Access Compliance Report

Public Rights-of-Way

(Curb Ramps)

Intersection ID: 20654	Main Street: E_INDEPENDENCE_BV	Cross Street: SARDIS_RD_NORTH	Location: NW
ADA ID: 0F69097E8720	Ramp Type: Perp	Initial Pass/Fail: Fail	Overall Compliance: No
Severity Score: 10			
Codes/Mitigation Info/Possible Solution		Field Measurements/Component Compliance

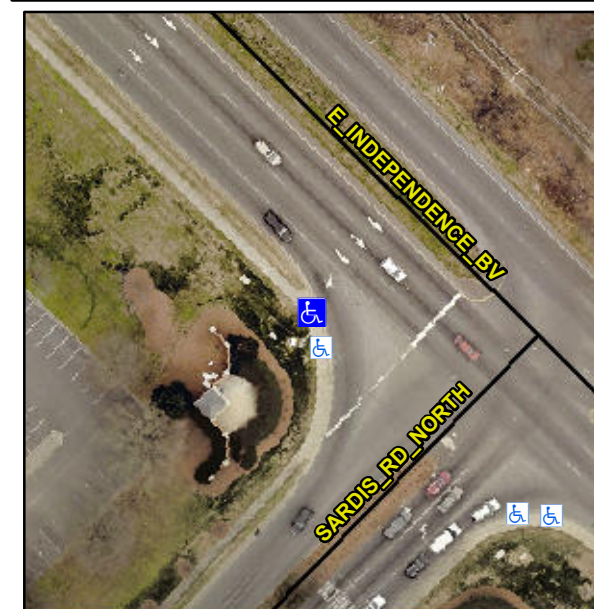
Not Found, R304.5.1, R304.5.3

Compliance	Description	Data	Compliance	Description	Data
N/A	Ramp Length (in)	39.0	Yes	Ramp Slope (%)	5.8
No	Ramp Width (in)	45.5	No	Ramp XSlope (%)	3.9
N/A	Flare Type LT	N/A	N/A	Flare Type RT	N/A
N/A	Flare Slope LT (%)	N/A	N/A	Flare Slope RT (%)	N/A
N/A	Flare Traversable LT?	N/A	N/A	Flare Traversable RT?	N/A
N/A	Landing Length (in)	N/A	N/A	DWS Provided?	N/A
N/A	Landing Width (in)	N/A	N/A	DWS Contrast?	N/A
N/A	Landing Slope (%)	N/A	N/A	DWS Length (in)	N/A
N/A	Landing X Slope (%)	N/A	N/A	DWS Full Width?	N/A
N/A	Landing Curb? (Y/N)	N/A	N/A	DWS Offset (in)	N/A
N/A	Shared Landing?	N/A			
N/A	Gutter Ponding?	N/A	N/A	Gutter Slope (%)	N/A
N/A	Gutter Lip Ht (in)	N/A	N/A	Gutter X Slope (%)	N/A
N/A	Painted X Walk1?	No	N/A	Painted X Walk2?	N/A
	X Walk 1 Direction	To NE		X Walk 2 Direction	N/A
N/A	X Walk 1 Width (in)	N/A	N/A	X Walk 2 Width (in)	N/A
	X Walk 1 Slope (%)	0.4		X Walk 2 Slope (%)	N/A
	X Walk 1 X Slope (%)	2.3		X Walk 2 X Slope (%)	N/A

Remove & Replace Entire Ramp.
